Assessment Officer Report Ivanhoe Grammar Senior Years Building

Permit No PA2403326
41 The Ridgeway Ivanhoe, VIC

Officer Assessment Report
Development Approvals & Design

Figure 13: comparison of Development Plan guide (blue) and proposal (red) lower ground and Level 1

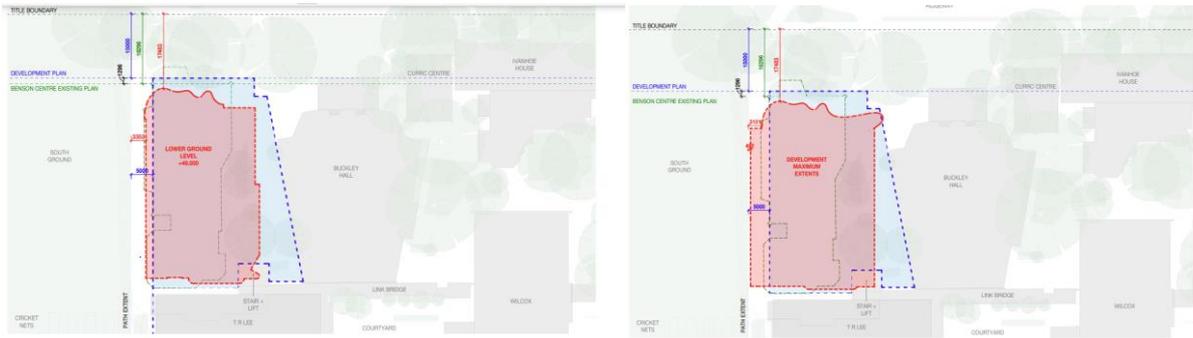
67. The following differences between the building envelope and the proposed building are summarised as:

- Shifting the building envelope further south, by up to 4.25 metres. This increases separation between the proposed building and Buckley Hall to the north (increased setbacks of approximately 2 metres to 9.7 metres), which maximises daylight access to the new classrooms and provides for an attractive outlook and the creation of an external amphitheatre area which has been cleverly designed respond to the existing topography / change in levels across the land. Relative to the south, it will cantilever over the existing east-west pathway, with 2.7 metres clearance to same, providing some weather protection to this pathway and achieving an appropriate connection with the South Ground. This does not compromise the intent of the Development Plan given it does not reduce any setbacks to residential interfaces (given the South Ground immediately abuts this interface) or increase any overshadowing impacts to residential dwellings to the southwest.

- The front setback of the Senior Years building to The Ridgeway is increased from 15 metres to 17.48 metres. The increased setback allows for the protection of canopy trees (Trees 58, 59 and 63) between the proposed building and The Ridgeway. The retention of vegetation will provide a visual break and retain the 'garden setting' of the locale. Given the building's main external entry is in the northwestern corner, this also achieves a well landscaped pedestrian entry point for users of the building.

68. These changes to the building envelope are considered to be consistent with the overall intention of the Development Plan and are supported. Banyule City Council have also reviewed the documentation submitted with the application and support the proposal, subject to the conditions which will be included on the planning permit.

Figure 14: comparison of Development Plan guide (blue) and proposal (red) in sections

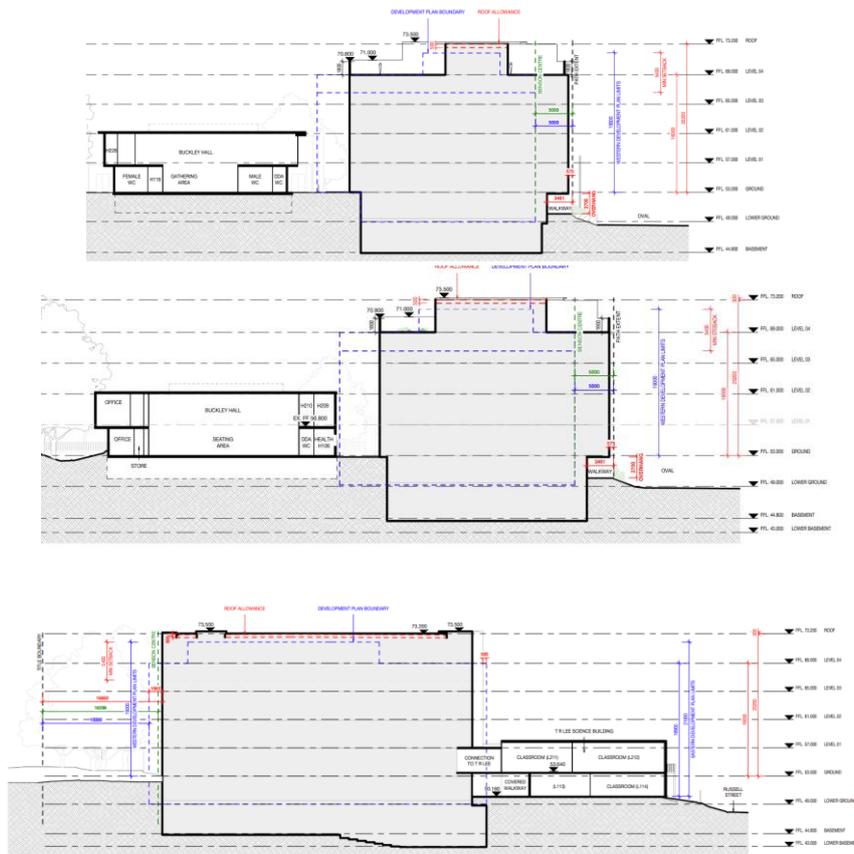
- Increasing height above the 19 to 21.9 metres envisaged for the west and east elevations respectively. The proposed building is 20.2 metres high to the west elevation and 23.4 metres to its east elevation. While this is higher than that nominated Development Plan, it has occurred as a response to the introduction of the sculptural 'ribbed' white brick western façade with varied setbacks and between realising and understanding the substantial changes in natural ground levels. The Development Plan envisaged a 16 metre high wall, with the uppermost 5.4 metres to have a staggered setback to minimise visual bulk. It is considered that the sculptural and ribbed western elevation, with increased setbacks, ensures the building will not appear visually bulky. The siting of the building ensures there are no unreasonable off-site amenity impacts as a result of the increased height.

Figure 16: trees proposed for removal in red, Landscape Plan prepared by Urban Initiatives Pty Ltd

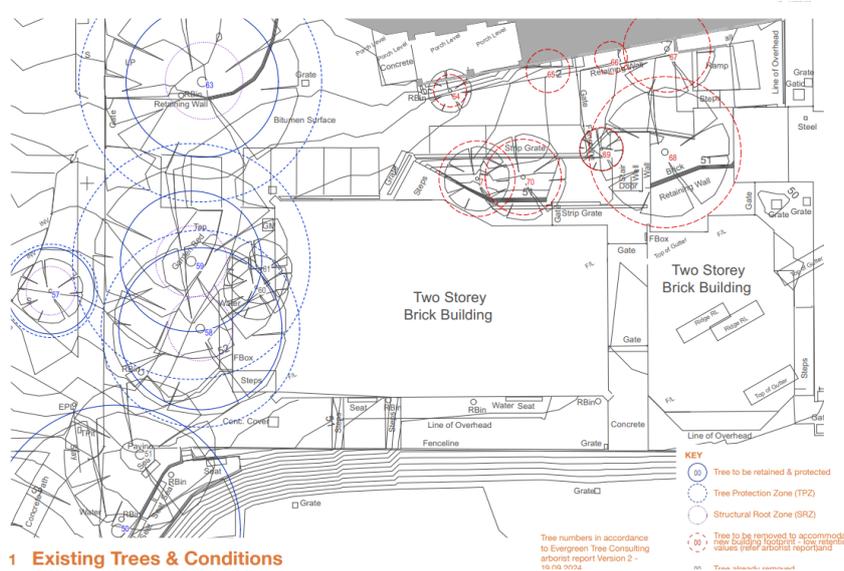
86. It is proposed to remove eight (8) trees (Trees : 64, 65, 66, 67, 68, 69, 70 & 71) to construct the new Senior Years Centre. These trees are located between the existing Benson Centre and Buckley Hall to the north.

87. Importantly, Tree(s). 58, 59 and 63 which are considered significant vegetation, are to be retained consistent with the Development Plan.
88. A landscape plan has been prepared by Urban Initiatives Pty Ltd and indicates replacement planting around the perimeter of the proposed Senior Years Centre.

89. An arborist report prepared by Evergreen Tree Consulting and the landscape plans prepared by Urban Initiatives was submitted with the application in support of the vegetation removal. The proposed extent of vegetation removal is considered appropriate for the following reasons:
